Economic Commission for Europe**Inland Transport Committee****World Forum for Harmonization of Vehicle Regulations****Working Party on Brakes and Running Gear****Eighty-second session**

Regulations Nos. 13 and 13-H - Clarifications**Proposal for amendments to Regulation No. 13 (Braking)****Submitted by the expert from France***

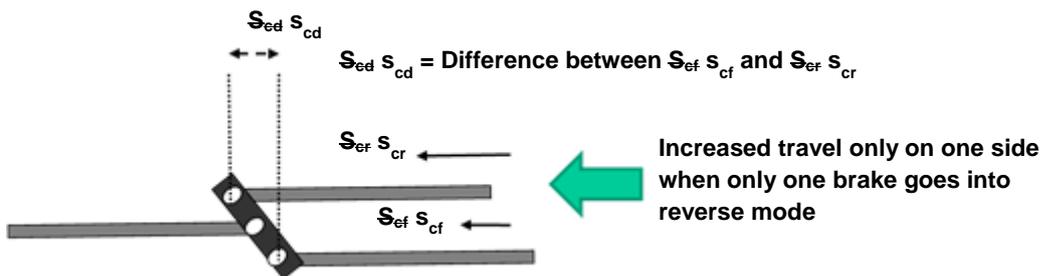
8.1.2. Drawing details are to be provided to demonstrate that the compensator articulation is sufficient to ensure equal cable tension is applied to each of the rear cables. The compensator needs to have sufficient distance across the width to facilitate the differential travels left to right. The jaws of the yokes also need to be deep enough relative to their width to make sure that they do not prevent articulation when the compensator is at an angle.

The compensator's permissible differential travel at compensator (s'_{cd}) shall be derived from:

$$s_{ed} \geq 1.2 \times (S_{ef} - S_{e'}) \quad s'_{cd} \geq 1.2 \times s_{cd}$$

$$s_{cd} = s_{cr} - s_{cf}$$

$$S_{e'} = S'/i_H \quad s_{cf} = s_B \times i_g \quad (\text{travel at compensator - forward operation}) \text{ and}$$

$$S_{e'} = 2 \cdot S_B/i_g$$

$$S_{ef} = S_f/i_H \quad s_{cr} = s_r \quad (\text{travel at compensator - rearward operation})$$

Annex 12, Appendix 1, Figure 5A, amend to read:

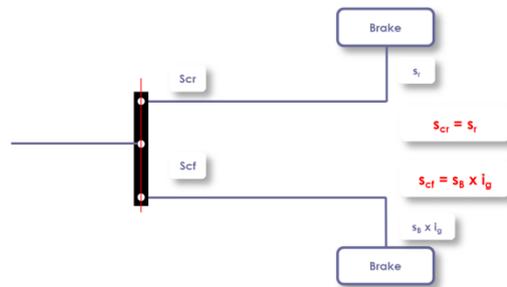
Annex 12, Appendix 4, paragraph 6.1.3., amend to read:

6.1.3. Maximum Compensator's permissible differential compensator travel $s_{ed} \quad s'_{cd}$ = mm (shall be greater than or equal to: $1.2 \times s_{cd}$)

1. Paragraph 8.1.2. aimed to check that the compensator is capable to accept a difference of the travel when one brake operates in forward direction and the other in rearward direction with a margin of twenty per cent.

2. The new formula expresses this above condition where s'_{cd} is an own characteristic of the compensator to be compared to s_{cd} which results from the characteristics of the brakes.

3. The value s_{cd} is equal to s_{cr} minus s_{cf} (see 2.3.12.). These two last values (in mm) come from the characteristics of the brakes measured without adjustment during the test.

4. As shown on the figure above:

$s_{cr} = s_r$ where s_r is the maximum permissible travel at the brake control lever when the trailer moves rearward (see 2.2.27.);

$s_{cf} = s_B \times i_g$ where s_B is the brake-shoe lift (brake-shoe application travel), in millimeters, measured on diameter parallel to applying device (see paragraph 2.2.21.); and

i_g is the reduction ratio between travel of brake lever and lift (application travel) at brake-shoe center (see 2.3.4.).
